HISTORIC AND DESIGN REVIEW COMMISSION

HDRC CASE NO: 2024-379
ADDRESS: 114 DEWBERRY ST
LEGAL DESCRIPTION: NCB 6461 (MISTLETOE ADDITION SUBDIVISION), BLOCK 1 LOT 57
ZONING: R-4, H
CITY COUNCIL DIST.: 1
DISTRICT: River Road Historic District
APPLICANT: Joseph Keresztury/True Stone Custom Homes, LLC
OWNER: Stephanie Pina/PINA DANIEL & STEPHANIE
TYPE OF WORK: New Construction
APPLICATION RECEIVED: November 04, 2024
60-DAY REVIEW: January 03, 2025
CASE MANAGER: Caitlin Brown-Clancy

REQUEST:

The applicant is requesting conceptual approval to construct a new 2-story, single-family residence totaling approximately a 2,400 sf building footprint with an attached porte cochere.

SITE PLAN

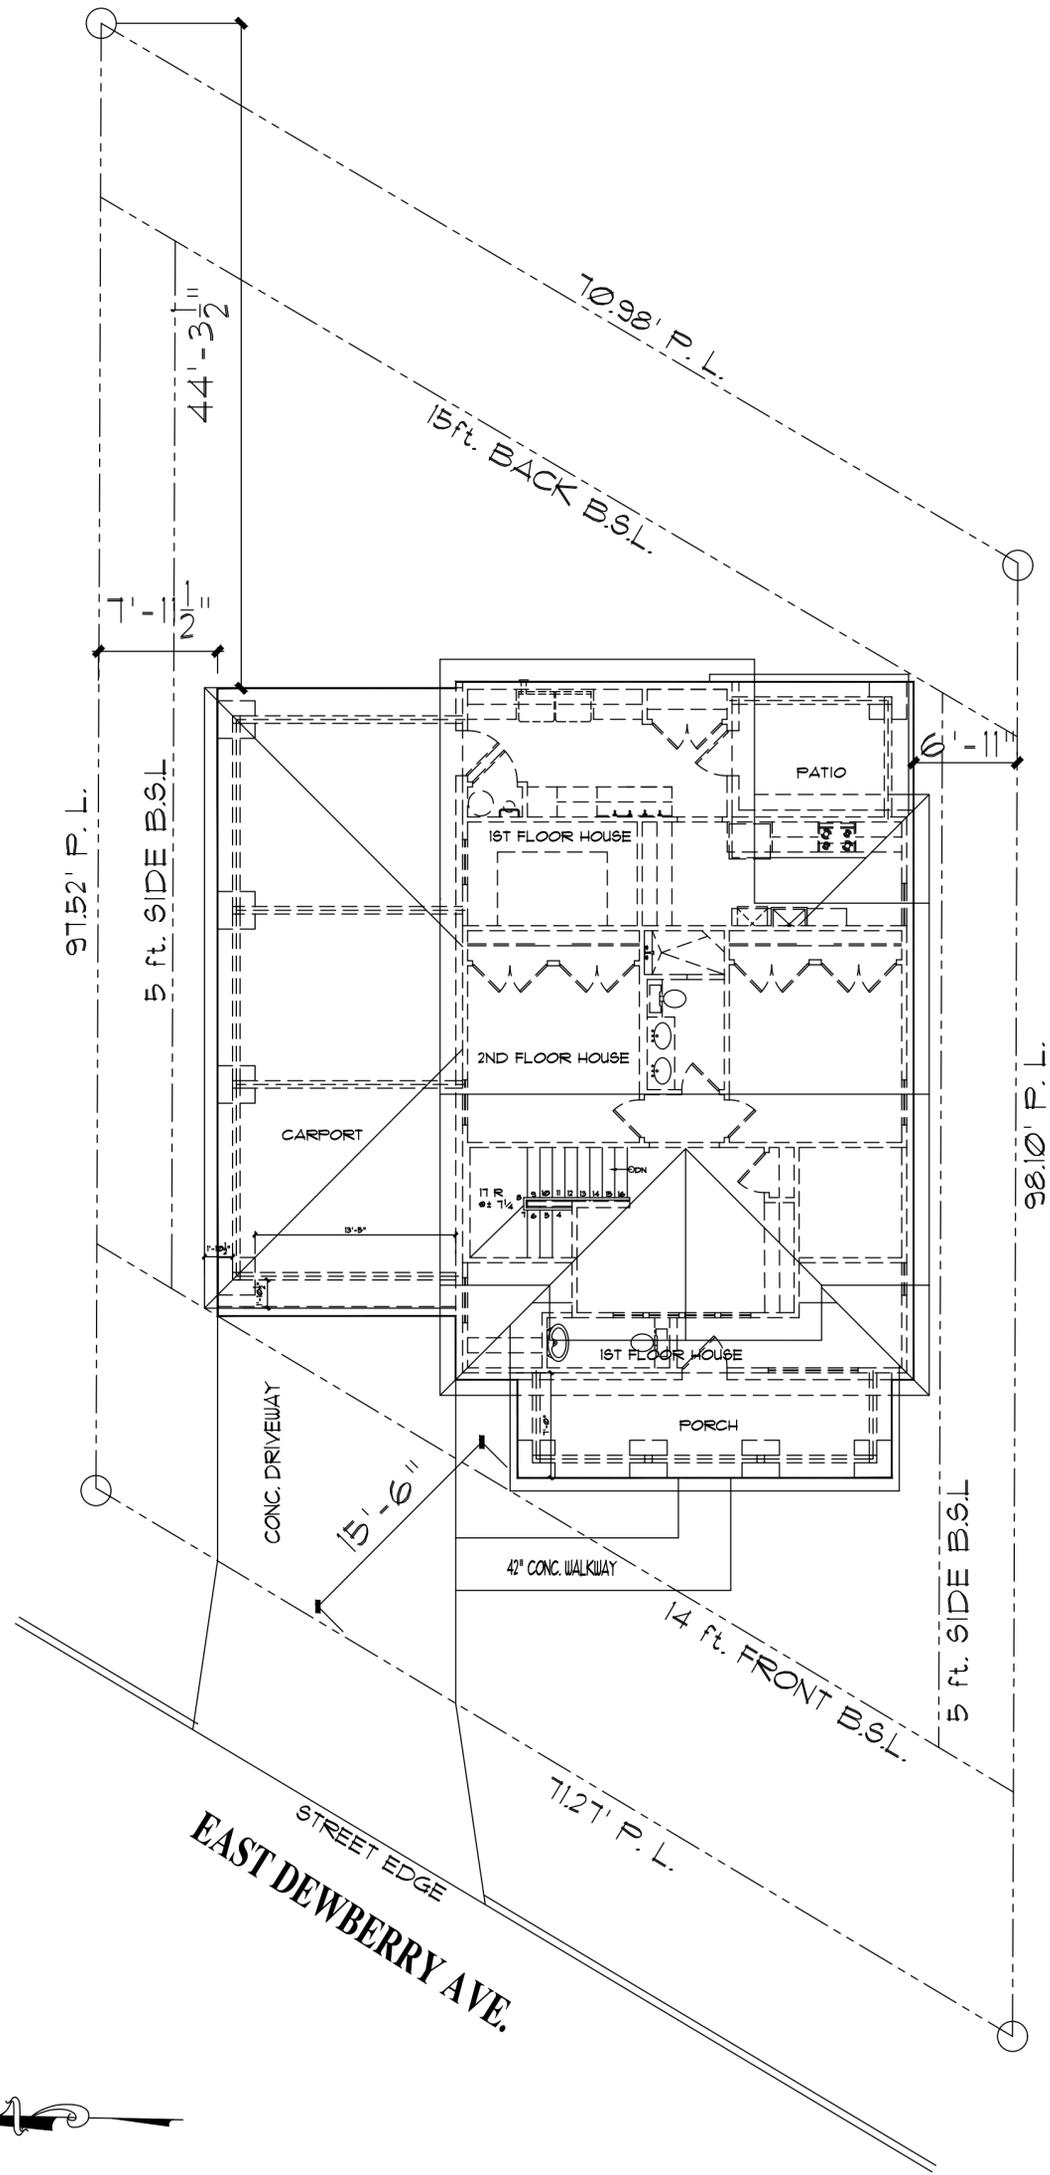
- o. DRIVEWAYS – The applicant has proposed one driveway but has not submitted a site plan with measurements. Staff finds the applicant should submit a measured site plan indicating driveway location, design, and curb cuts to be submitted to Staff prior to final approval.

- b. That the applicant submits a measured site plan communicating the driveway location, design, and curb cuts, a landscaping plan, and exterior door specifications as noted in findings k and n.

ELEVATIONS

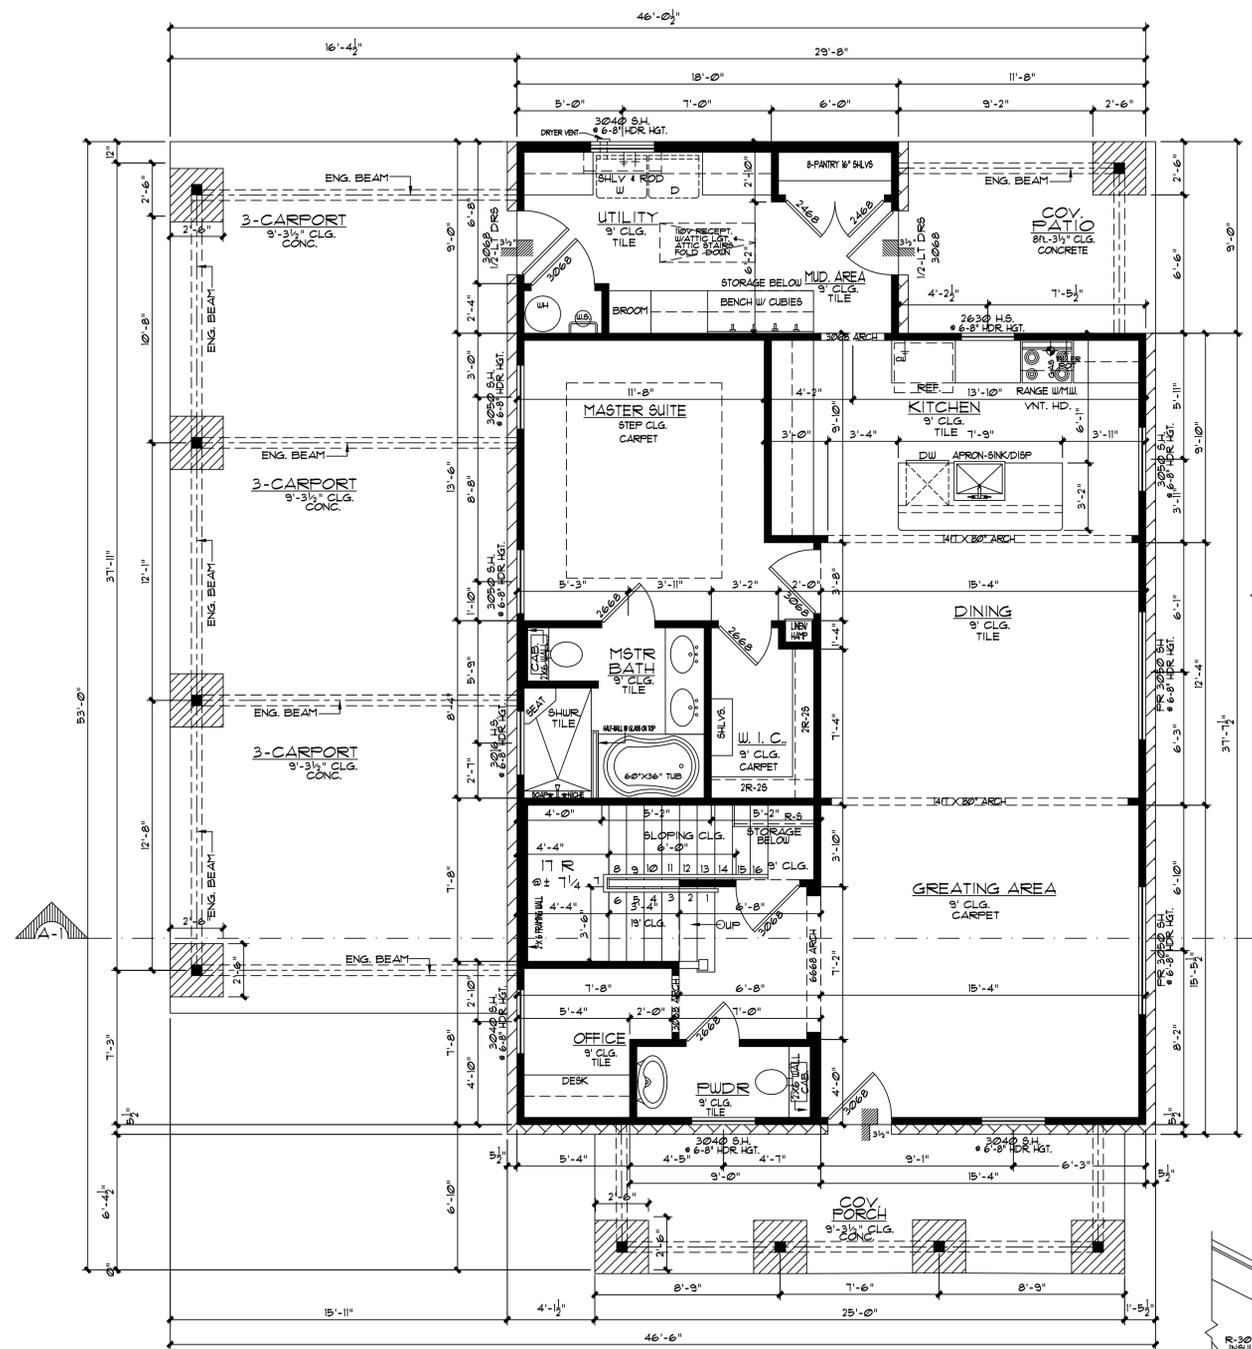
Jeffrey Fetzer – Suggested revising window placement on right and left elevations to be centered on gable vent. Consider window type/placement of 10 light window on left elevation to read more subordinate. Reduce ceiling heights/incorporate vaulted ceiling to bring overall height of structure down even further as second story is “top-heavy”. Incorporate 6” mullions on all “ganged” windows. Utilize taller window proportion for all sashed windows.

Jimmy Cervantes - Add additional fenestration to gable on right elevation

Roland Mazuca – Center windows on side gables and utilize taller window proportion for all sashed windows.

- ***Reduce height of second story gable***
- ***Refine window placement on second story gables***
- ***Utilize taller window proportion on all sashed windows***
